**FAU ROUTE 1467 (31ST STREET)
OVER SALT CREEK
SECTION: 2020-161-BR
PROJECT: STP-3JLU(458)
BRIDGE DECK OVERLAY AND JOINT REPAIR
COOK COUNTY**

**31ST STREET
OVER SALT CREEK
SN 016-0868**

INDEX OF SHEETS, HIGHWAY STANDARDS, GENERAL NOTES, AND COMMITMENTS		REVISED SHEET 12/29/2020		REV-SEP	
		SCALE: N.T.S.	SHEET OF SHEETS	STA. TO STA.	ILLINOIS FED. AID PROJECT
F.A.P. RTE. 1467	SECTION 2020-161-BR	COUNTY COOK	TOTAL SHEETS 58	SHEET NO. 2	CONTRACT NO. 62M49

**DIAPHRAGM REPLACEMENT DETAILS
STRUCTURE NO. 016-0868**

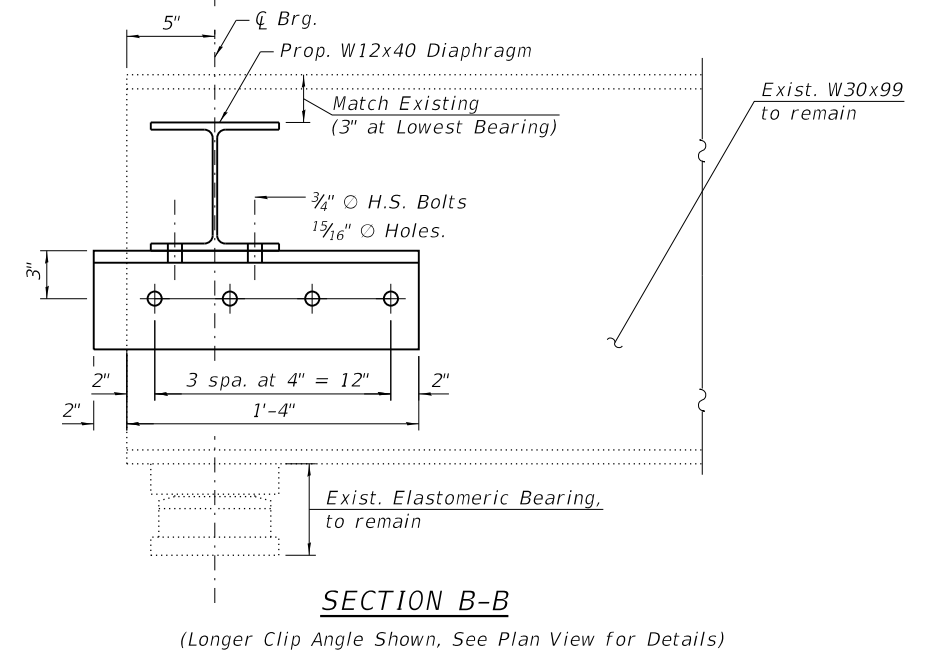
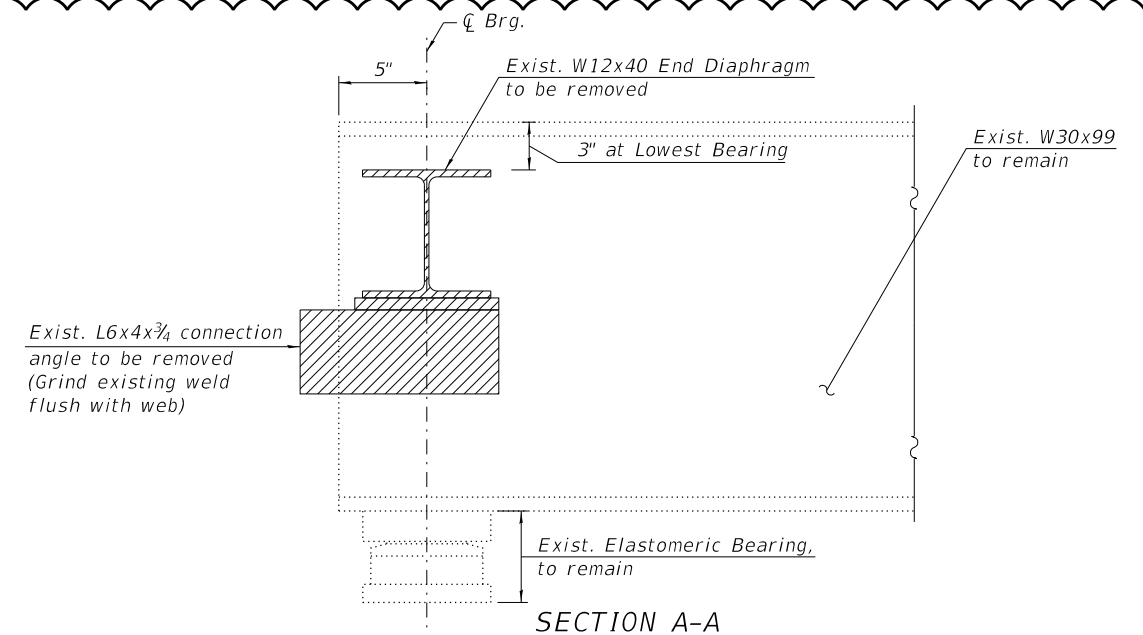
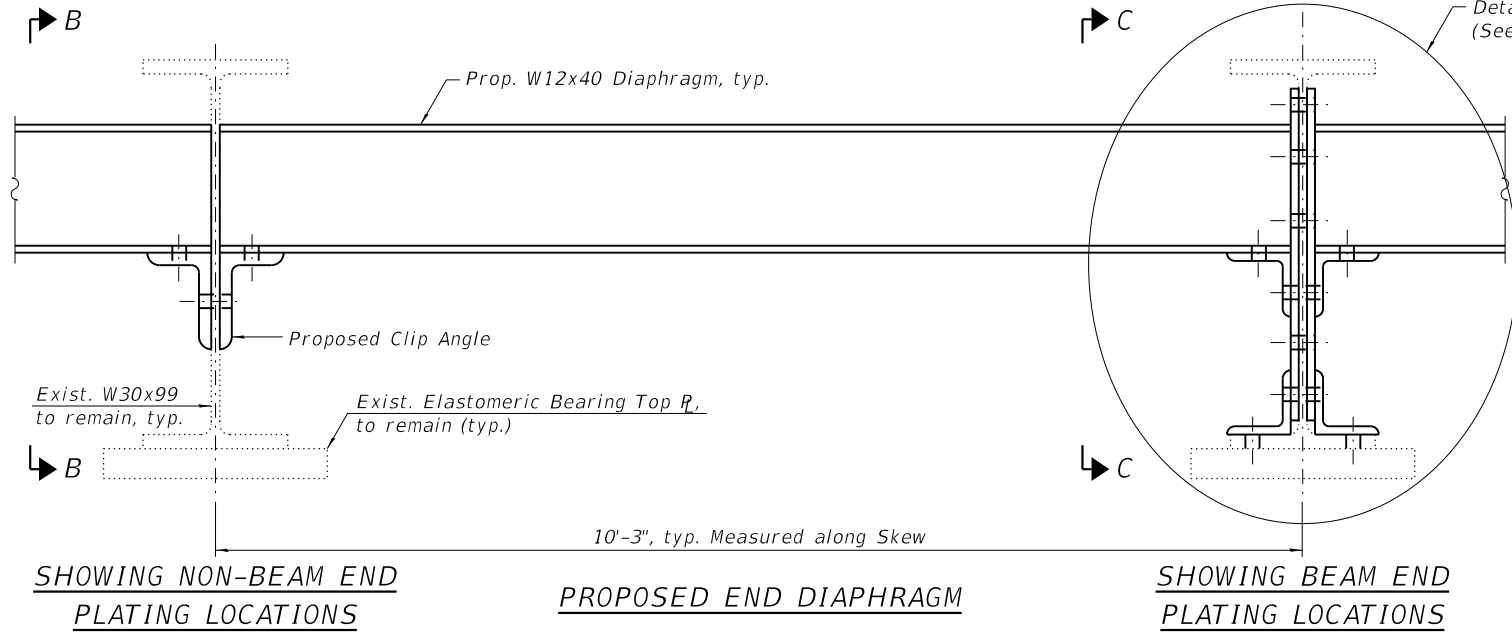
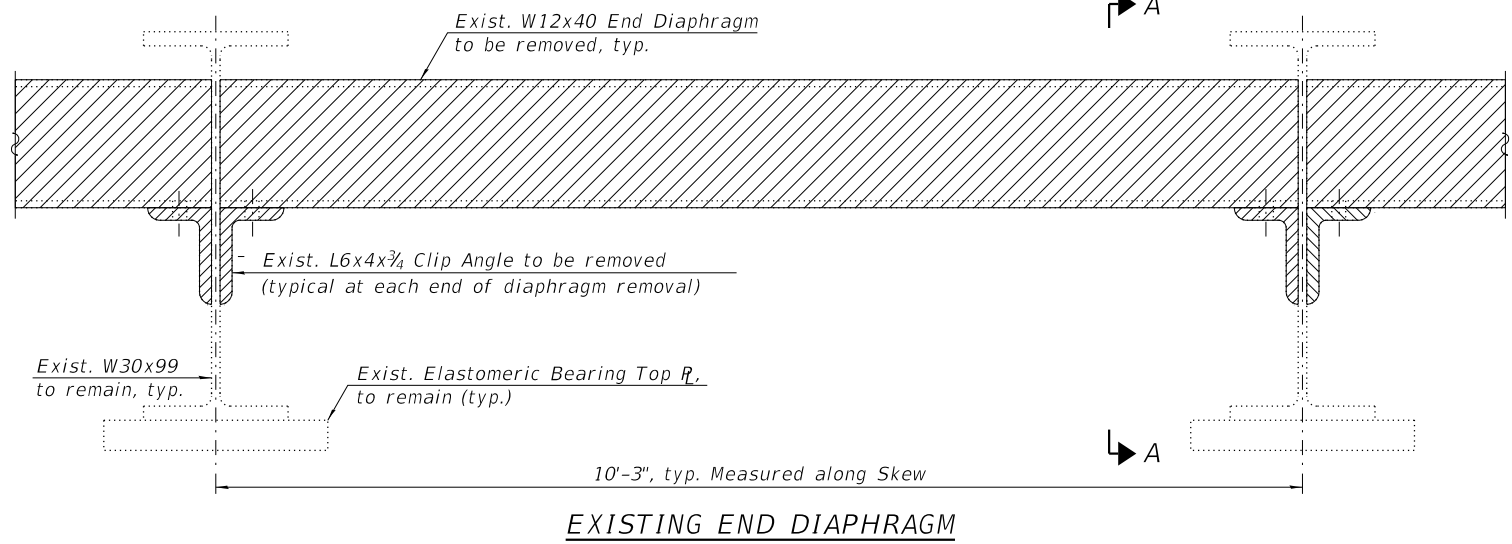
ENTIRE SHEET REVISED 12/29/2020

PLAN VIEW
BEAM END PLATING LOCATIONS
 (West Abutment Shown, East Abutment Similar)

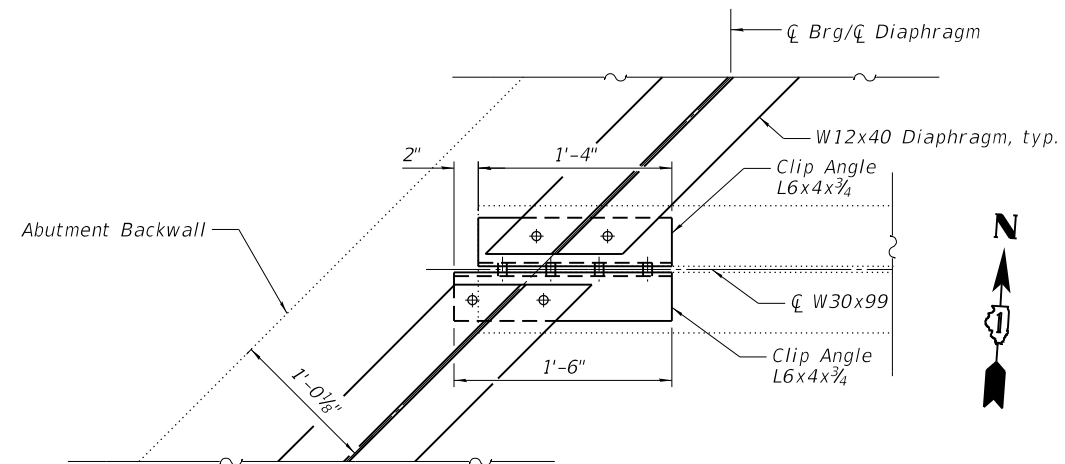
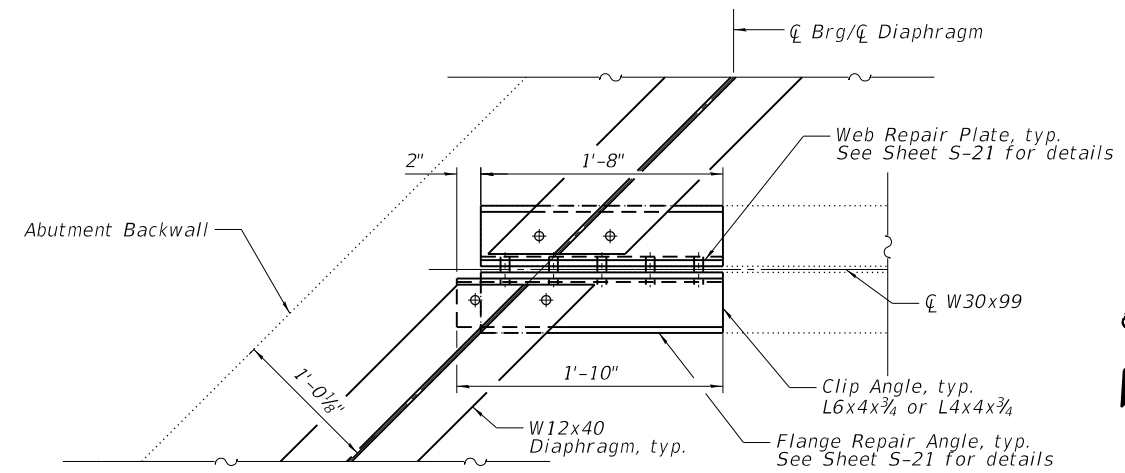
ENTIRE SHEET REVISED 12/29/2020

BEAM REPAIR DETAILS
STRUCTURE NO. 016-0868

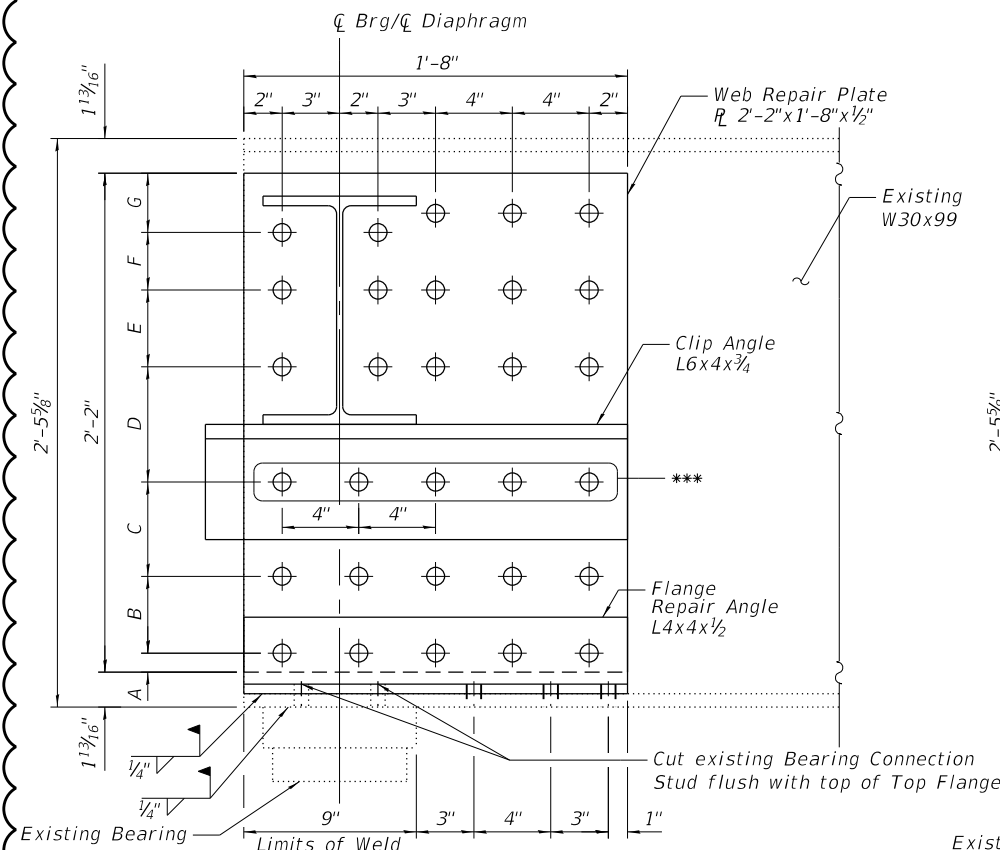
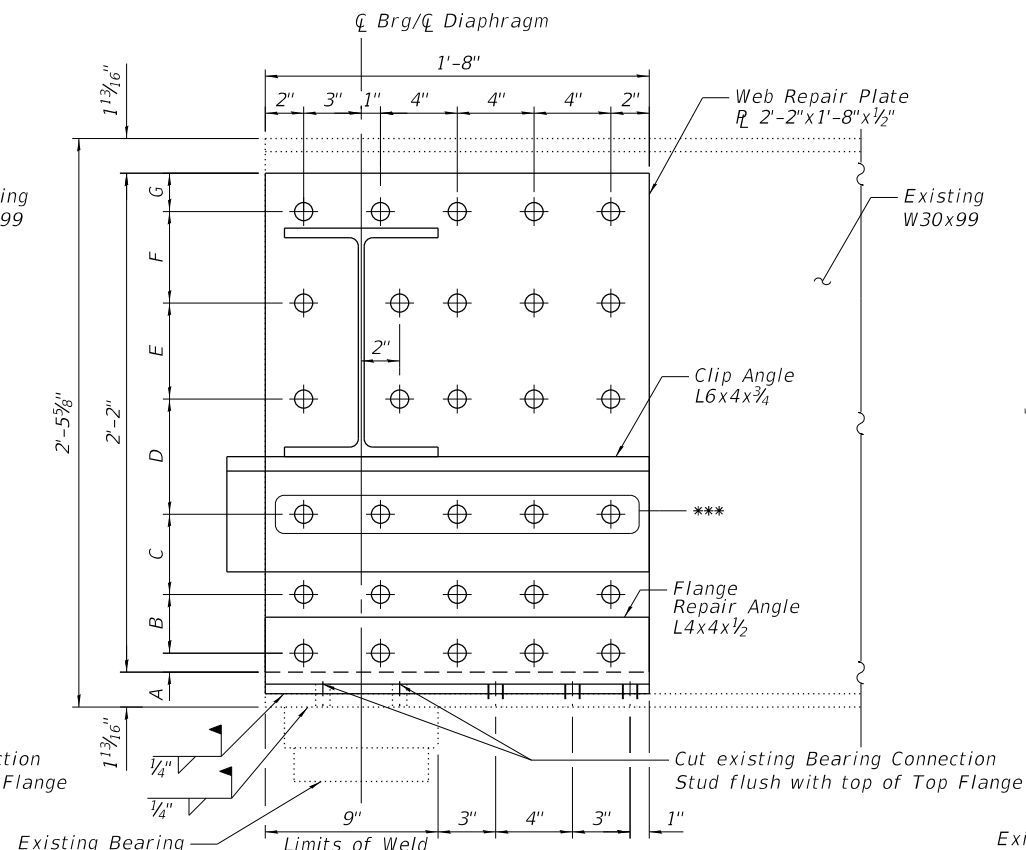
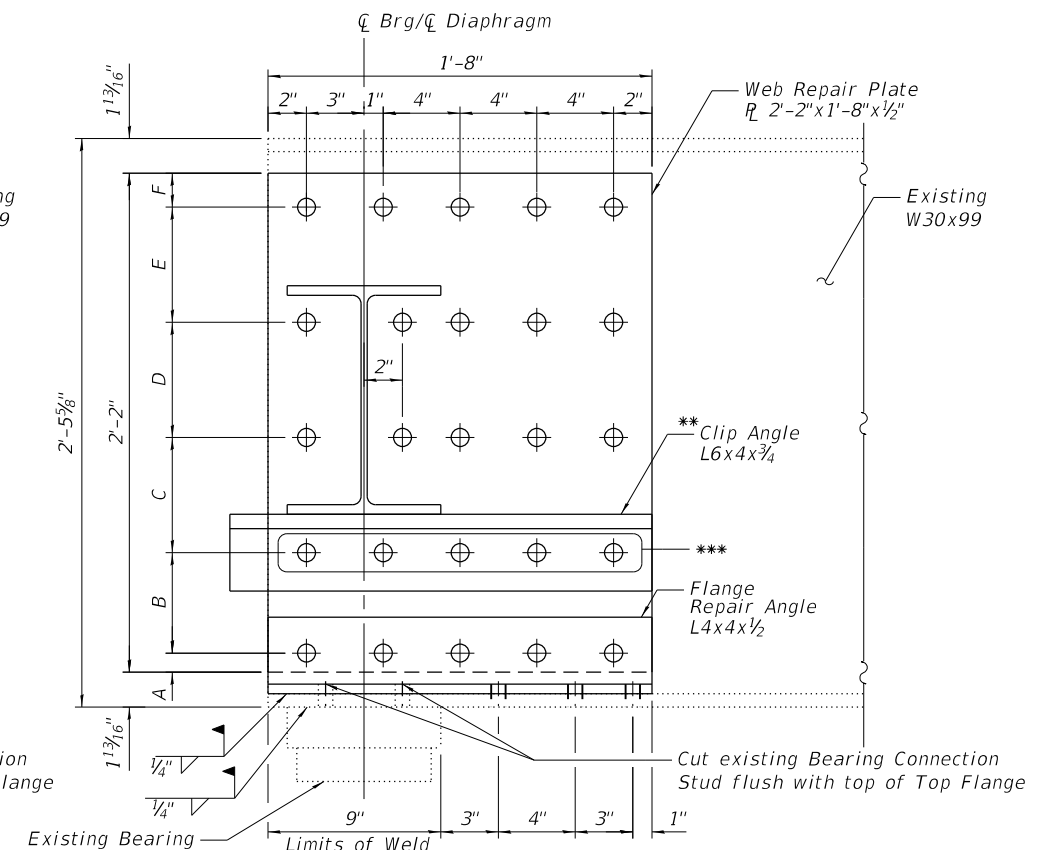
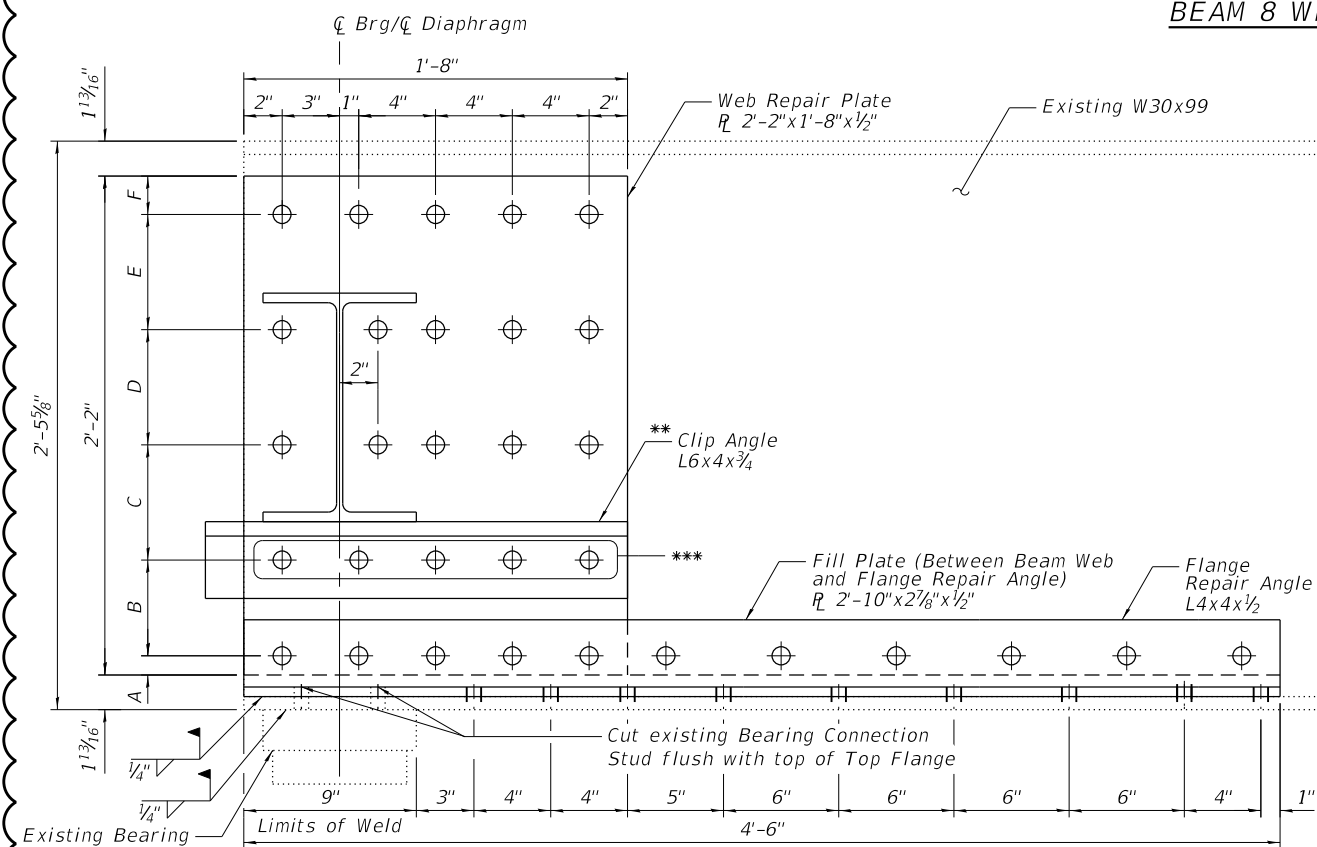
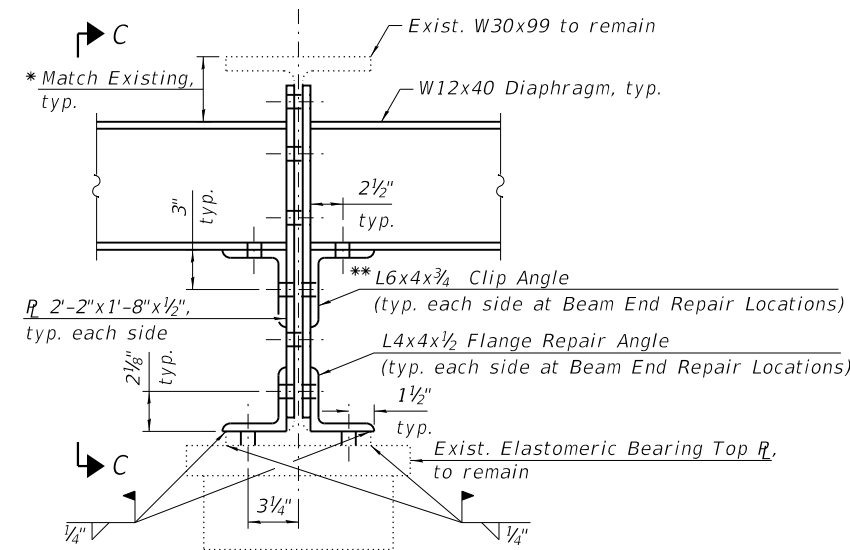
ENTIRE SHEET REVISED 12/29/2020
